**INFORMATION SHEET FOR INSTALLATION OF A DOOR REPLACEMENT ASSEMBLY OR A
DELIVERY PAN REPLACEMENT ASSEMBLY IN A SHOWCASE 143 OR SHOWCASE 144
MERCHANDISER EQUIPPED WITH GUM AND MINT SELECTIONS**

Carefully read the information presented on Page 2 of this Information Sheet before installing the replacement Door Assembly or Delivery Pan Assembly in the Merchandiser.

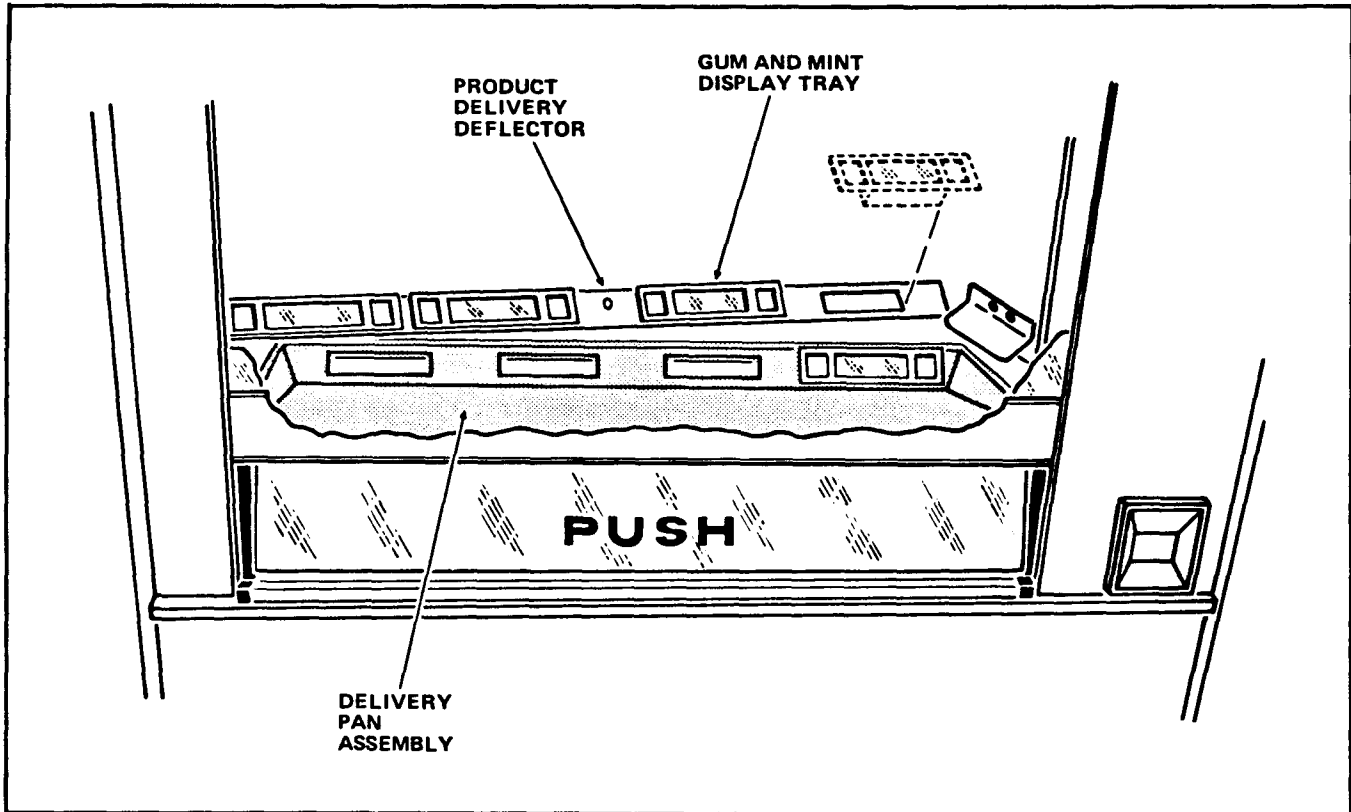
Some early production Showcase 143 and Showcase 144 Merchandisers were produced with the Gum and Mint Display Trays mounted in the Product Delivery Deflector inside the Cabinet. To improve visibility of the Gum and Mint Display, these Display Trays are now mounted in the Delivery Pan Assembly of the Door Assembly.

If the replacement Door Assembly or the replacement Delivery Pan Assembly is installed on an early production Merchandiser which has Gum and Mint Display Trays

mounted inside the Cabinet, remove the four Display Trays from the Cabinet and install them in the Delivery Pan Assembly as shown in Figure .

If desired, a Product Delivery Deflector which is equipped with a SOLD OUT label but which does not have cut-outs for the Gum and Mint Display Trays may be purchased from National Vendors Parts Department to replace the early production type Product Delivery Deflector. Order part number 143-1055.
